# SANDY SPRING MEADOW AMENDMENT PACKAGE

M-NCPPC FILE NUMBER: 11982180A, 81982092A

1. REMOVE PARCEL B AND LOTS 7-17, BLOCK A OF THE SANDY SPRING MEADOW SUBDIVISION FROM THE PRELIMINARY PLAN.
2. REDUCE THE DENSITY FROM A TOTAL OF 60 DWELLING UNITS TO 49 DWELLING UNITS. THE OVERALL DENSITY FOR SANDY SPRING MEADOW WILL BE 4.28 DWELLINGS PER ACRE, WHICH COMPLIES WITH THE CLUSTER SUBDIVISION STANDARDS.
3. REDUCE THE APPROVED GREEN AREA FROM 223,800 SQUARE FEET TO 202,862 SQUARE FEET. THE OVERALL GREEN AREA PROVIDED FOR SANDY SPRING MEADOW WILL EXCEED THE MINIMUM REQUIREMENT OF 98,000 SQUARE FEET (I.E., 2,000 SQUARE FEET PER DWELLING UNIT UNDER THE PRIOR CLUSTER SUBDIVISION STANDARDS).
4. PROPOSED HALF COURT BASKETBALL COURT.

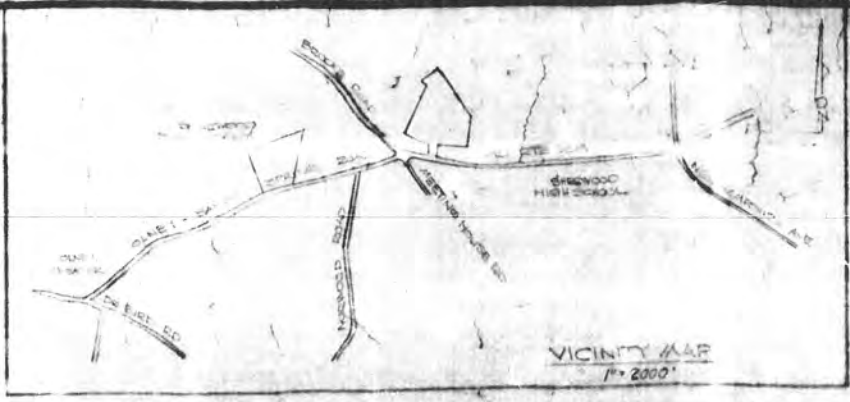
- ▲ REMOVE PARCEL B AND LOTS 7-17, BLOCK A OF THE SANDY SPRING MEADOW SUBDIVISION FROM THE PRELIMINARY PLAN.
- ▲ REDUCE THE DENSITY FROM A TOTAL OF 60 DWELLING UNITS TO 49 DWELLING UNITS. THE OVERALL DENSITY FOR SANDY SPRING MEADOW WILL BE 4.28 DWELLINGS PER ACRE, WHICH COMPLIES WITH THE CLUSTER SUBDIVISION STANDARDS.
- ▲ REDUCE THE APPROVED GREEN AREA FROM 223,600 SQUARE FEET TO 202,652 SQUARE FEET. THE OVERALL GREEN AREA PROVIDED FOR SANDY SPRING MEADOW WILL EXCEED THE MINIMUM REQUIREMENT OF 98,000 SQUARE FEET (I.E., 2,000 SQUARE FEET PER DWELLING UNIT UNDER THE PRIOR CLUSTER SUBDIVISION STANDARDS).
- ▲ PROPOSED HALF COURT BASKETBALL COURT.

Scale 1" = 30'  
 Sheet  
**CS-103**

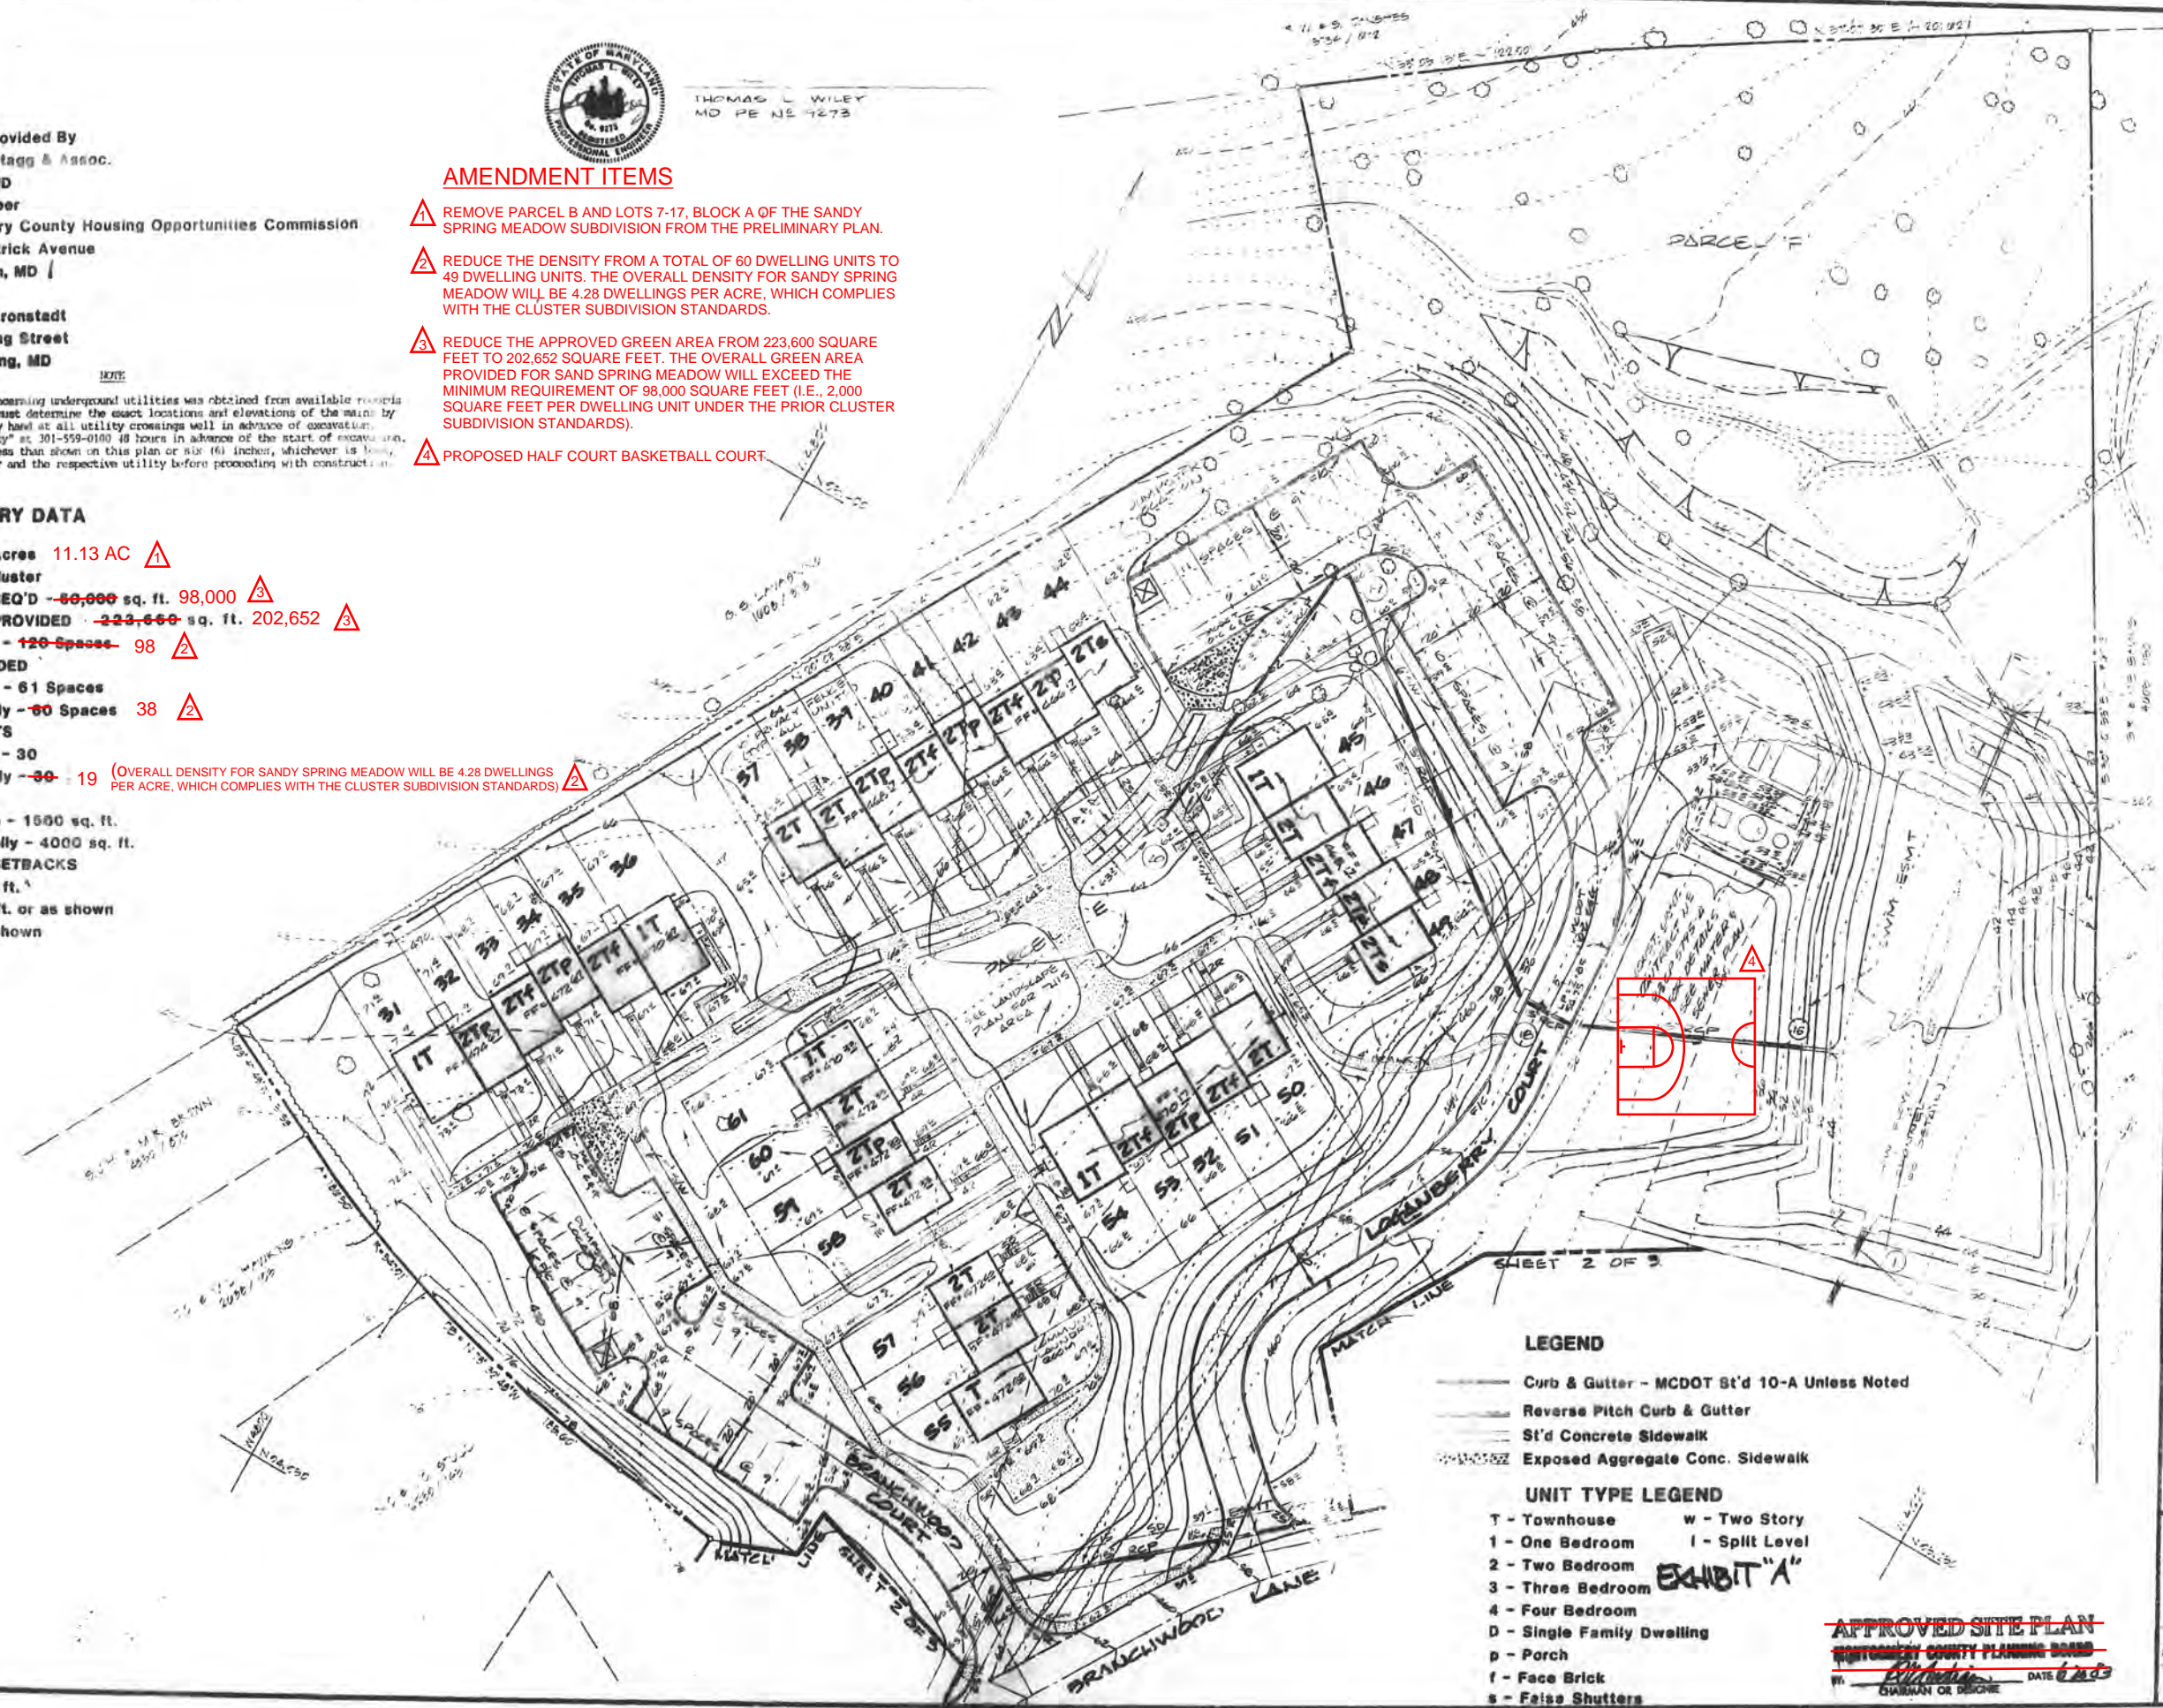
- 1 REMOVE PARCEL B AND LOTS 7-17. BLOCK A OF THE SANDY SPRING MEADOW SUBDIVISION FROM THE PRELIMINARY PLAN.
- 2 REDUCE THE DENSITY FROM A TOTAL OF 60 DWELLING UNITS TO 49 DWELLING UNITS. THE OVERALL DENSITY FOR SANDY SPRING MEADOW WILL BE 4.28 DWELLINGS PER ACRE, WHICH COMPLIES WITH THE CLUSTER SUBDIVISION STANDARDS.
- 3 REDUCE THE APPROVED GREEN AREA FROM 223,600 SQUARE FEET TO 202,652 SQUARE FEET. THE OVERALL GREEN AREA PROVIDED FOR SANDY SPRING MEADOW WILL EXCEED THE MINIMUM REQUIREMENT OF 98,000 SQUARE FEET (I.E., 2,000 SQUARE FEET PER DWELLING UNIT UNDER THE PRIOR CLUSTER SUBDIVISION STANDARDS).
- 4 PROPOSED HALF COURT BASKETBALL COURT.
